**James Bland Redevelopment Block “F”/ Phase 5
 Master Plan Amendment #2011-0008
 CDD Concept Plan Amendment #2011-0006
 Development Special Use Permit #2011-0022**

Application	General Data	
Project Name: James Bland/Old Town Commons – Block “F”/Phase 5 Location: 998 North Alfred Street & 1000 First Street Applicant: Alexandria Redevelopment and Housing Authority (ARHA) and GPB Associates, LLC c/o EYA; represented by Kenneth Wire, attorney	PC Hearing:	December 6, 2011
	CC Hearing:	December 17, 2011
	If approved, DSUP Expiration:	December 17, 2014 (3 years)
	Plan Acreage:	2.11 Acres – Block “F” 8.49 Acres – Entire Site
	Zone:	CDD #16
	Proposed Use:	Townhouse and Multi-family
	Dwelling Units:	62 multi-family units (Block F) 365 units (all five blocks)
	Small Area Plan:	Braddock Road Metro and Braddock East Plans
	Historic District:	Parker Gray
	Green Building:	Will conform to requirements in DSUP 2008-0013

Purpose of Application
A consideration of requests to amend Development Special Use Permit #2008-0013 (James Bland) to construct three multi-family buildings instead of one multi-family building on Block “F” and amend the Braddock East Master Plan and CDD Concept Plan to increase

Attachment #2 – Open Space Expansion

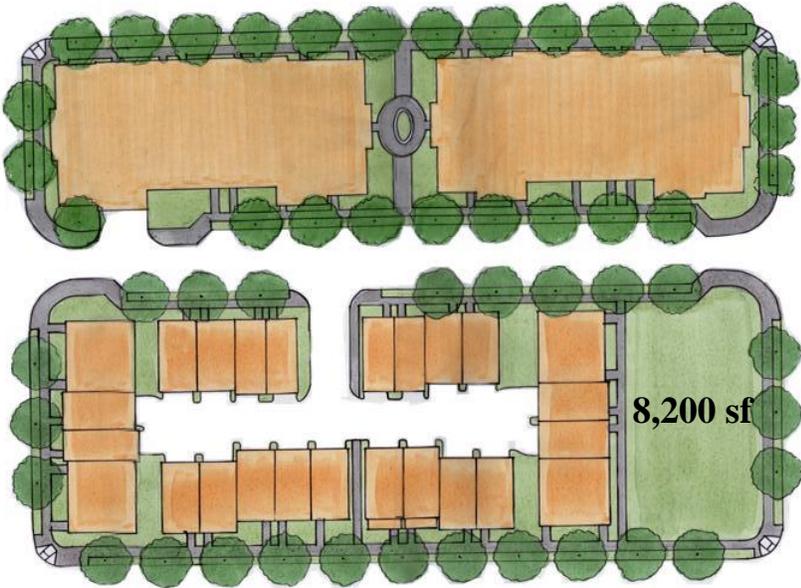
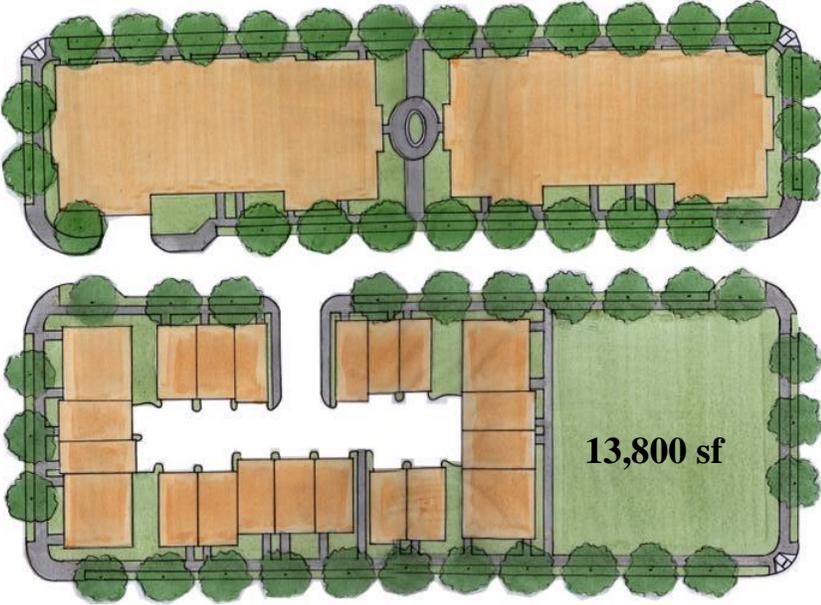
9. The applicant shall revise the site plan to eliminate 4 units in the southwestern block to provide a larger open space area at the corner of Montgomery Street and N. Alfred Street as generally depicted in *Attachment #2*. The park shall be subject to the following, to the satisfaction of the Directors of P&Z and RP&CA:

- b. In order to increase the size and viability of the proposed major park at the James Bland Redevelopment site, it is proposed that the City purchase from ARHA four market rate building lots adjacent to the planned open space at the southwest corner of Montgomery and Alfred Streets. This purchase of the four lots will increase the size of the park from about 8,200 square feet to approximately 13,000 square feet.
